ENGINE - HP COMPRESSOR - STAGE 10 CASE ASSEMBLY WITH INTEGRAL FRONT RETAINING ARM FOR  
SEAL RING - CATEGORY CODE 7 - MOD.ENG-72-0185

V2500-ENG-72-0185

Location of stage 10 compressor case assembly  
Fig.1

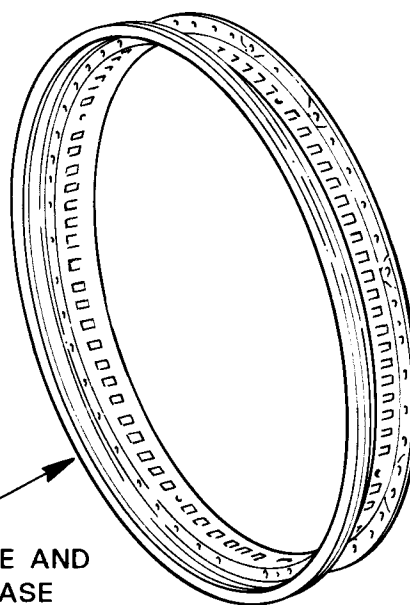
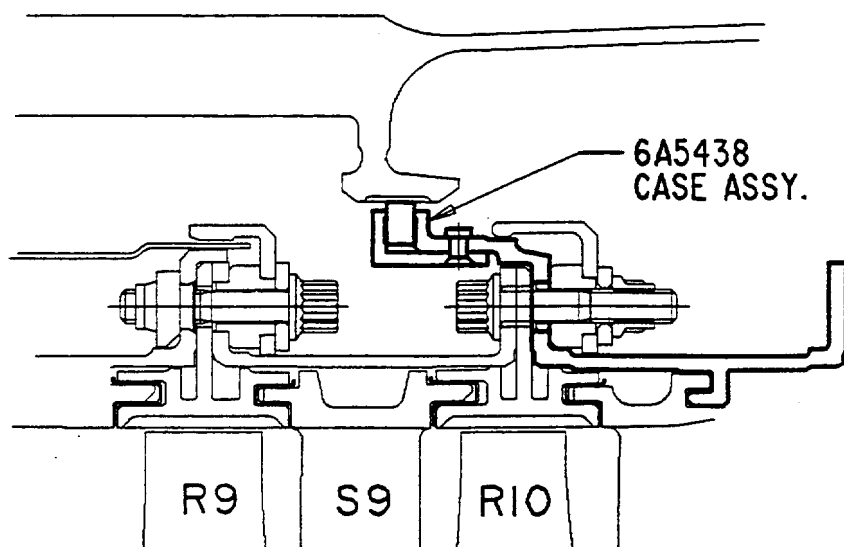
REMOVE 6A5438 CASE AND  
INSTALL 6A5624 CASE

View on stage 10 compressor case assembly - Before and after alteration  
Fig.2

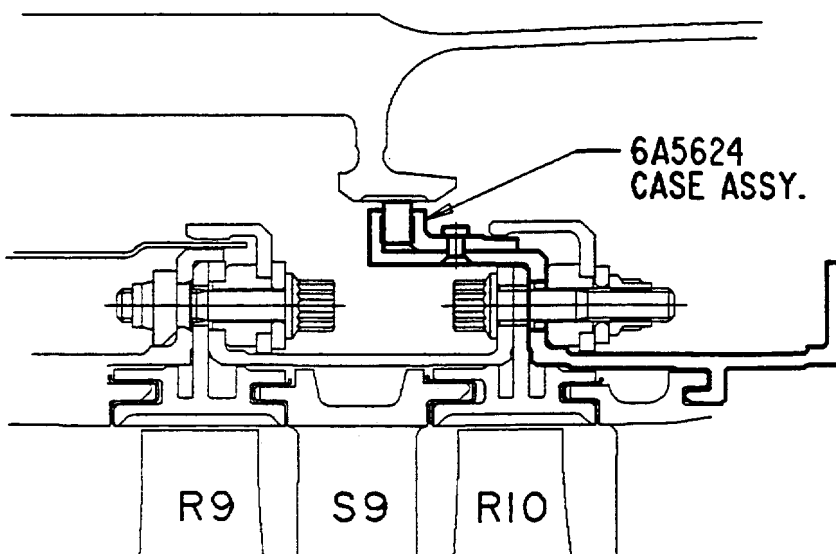
This Service Bulletin instructs a new HP compressor stage 10 case assembly with the integral seal retaining arm extended forwards to support the front face of the seal ring.

The retainer is transferred to the outside of the stage 10 case to support the rear face of the seal ring.

At engine build the integral seal retaining arm supports the ring seal thus lowering build stress levels, enabling a reduction in the number of rivets on the retainer from 96 to 24.
